RS-01-118

LaSalle County Station, Units 1 and 2
Facility Operating License Nos. NPF-11 and NPF-18
NRC Docket Nos. 50-373 and 50-374

Subject: Request for Amendment to Technical Specifications and
Relief Request Related to the Surveillance Requirement for the Automatic
Depressurization System Valves During Manual Actuation

GRAPHIC OF SAFETY/RELIEF VALVE
WITH AUXILIARY ACTUATING DEVICE

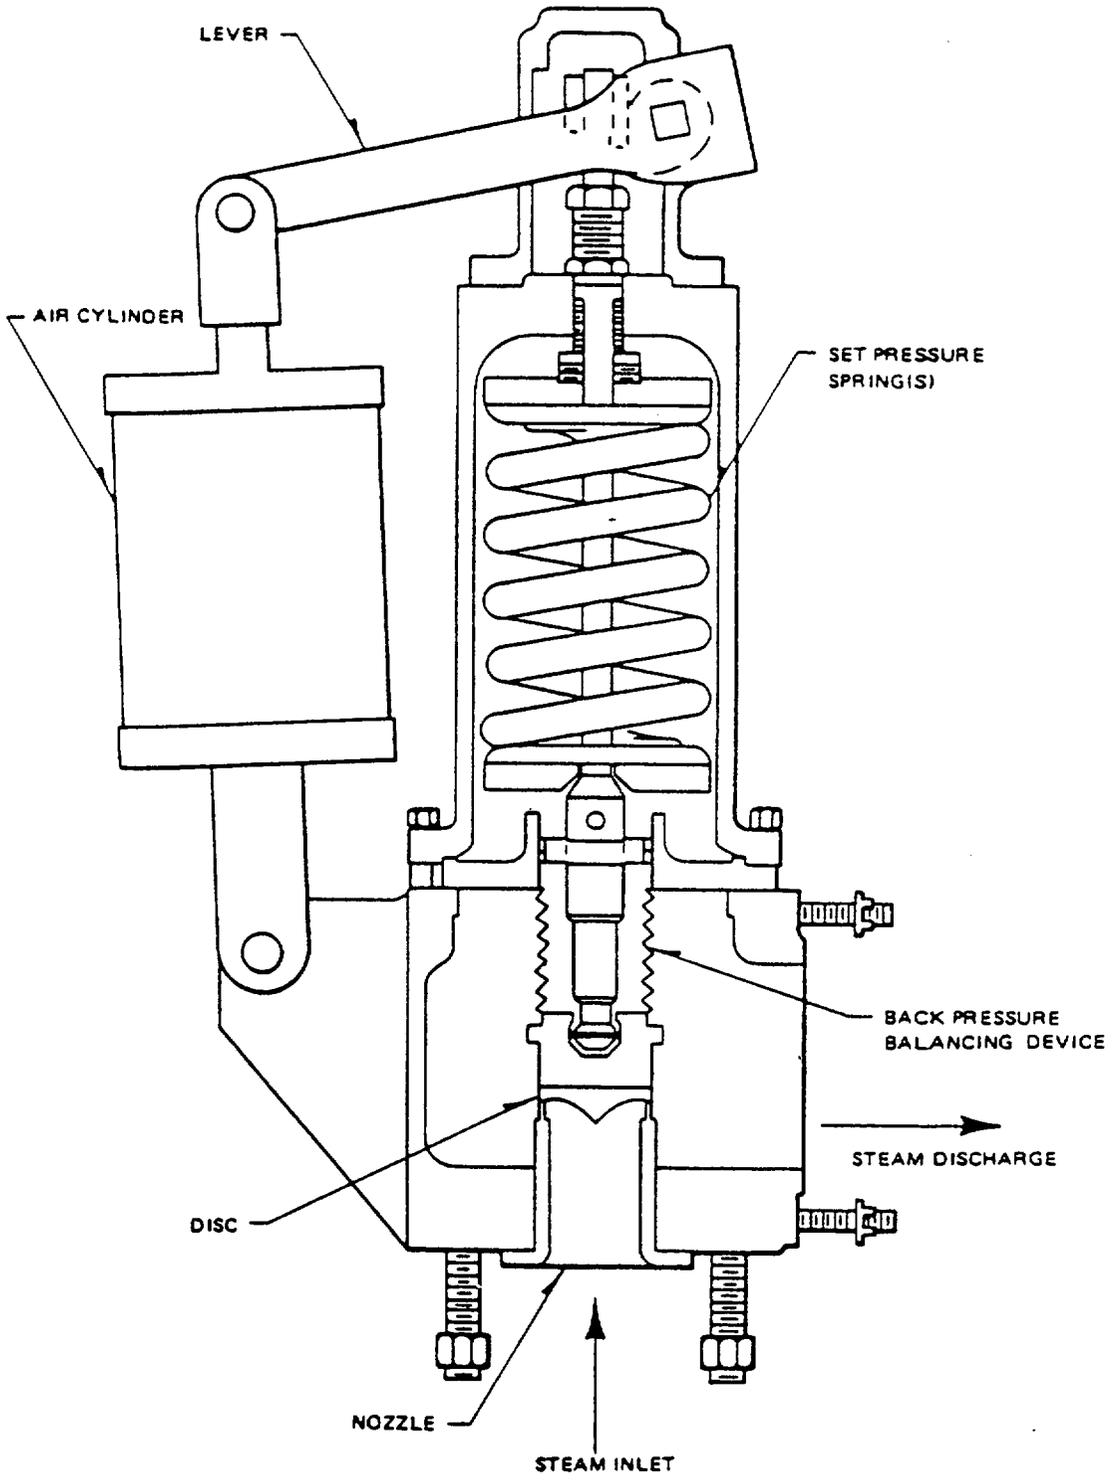
LaSalle County Station, Unit 1 and Unit 2, ADS valves are Crosby Dual Function S/RVs, Model HB-65-BP, that are designed to perform as either a safety valve or as a relief valve. The safety mode of operation is independent and separate from the relief mode. Major ADS valve components are shown on the attached Figure.

The relief mode of operation is initiated when an electrical signal is received at any or all of the solenoid valves located on the pneumatic relief-mode actuator assembly. The manual actuation of the ADS valves is initiated from the control room. The solenoid and air control valve will open to allow an air source to pressurize the lower side of the piston in the pneumatic cylinder to push it upwards. This action is transmitted through a lever arm and pivot mechanism which in turn pulls the valve lifting nut upwards, thereby opening the valve to allow steam discharge through the valve. Upon deenergization of the solenoid, the air valve will reposition to allow the pressurized air in the cylinder to vent to atmosphere and thus close the valve.

The proposed changes to SR 3.5.1.8 will result in the testing of the manual actuation of the S/RVs being performed in two overlapping steps in accordance with the requirements of SR 3.4.4.1 and the proposed requirements of SR 3.5.1.8. The SR 3.4.4.1 setpoint testing of the ADS valves is performed after the valve and actuator assemblies have been removed from the plant and transported to an approved vendor. The valves are bench tested at the vendor location to verify the safety and relief mode of valve operation. The safety mode is tested by verifying the pressure required below the valve disc to open the valve is consistent with design requirements. The relief mode is tested by providing air to the valve actuator and verifying the performance of the valve actuator, lever and pivot mechanism to open the valve.

The proposed changes to SR 3.5.1.8 will require the testing of the ADS valve manual relief mode after they are installed in the plant. The testing will be performed with the actuator uncoupled from the valve stem to allow the testing of the manual actuation electrical circuitry, manual actuation solenoid and air control valve, and the actuator without causing the ADS valve to open.
